## Change Order #6 Las Milpas Road

Project: Las Milpas Road  
Contract: C-22-0094-09-06(ARPA 22-1-122-109)  
Limits: McColl Rd (FM 3062) to 10<sup>th</sup> Street (FM 336)

### Summary of Change Order No. 6 (CO#6)

# CONSTRUCTION CONTRACT CHANGE ORDER NUMBER: 6

**TRAFFIC RAIL FOUNDATION AND MISCELLANEOUS DETAILS**

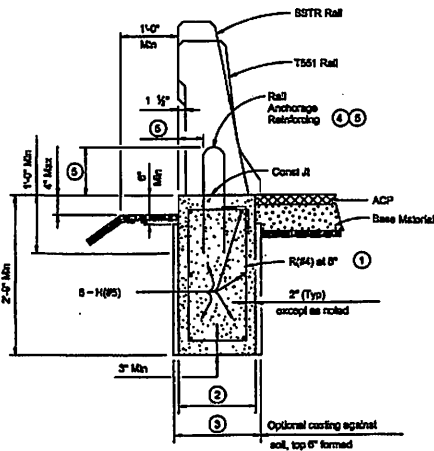
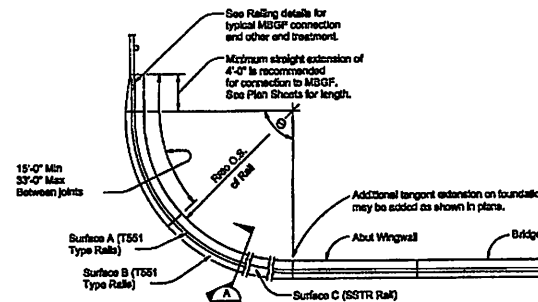
**CO #6 - Change Order #6**  
Eliminate 1-36" well and extend the 12" irrig. line an additional 40LF. Add concrete rail foundation.
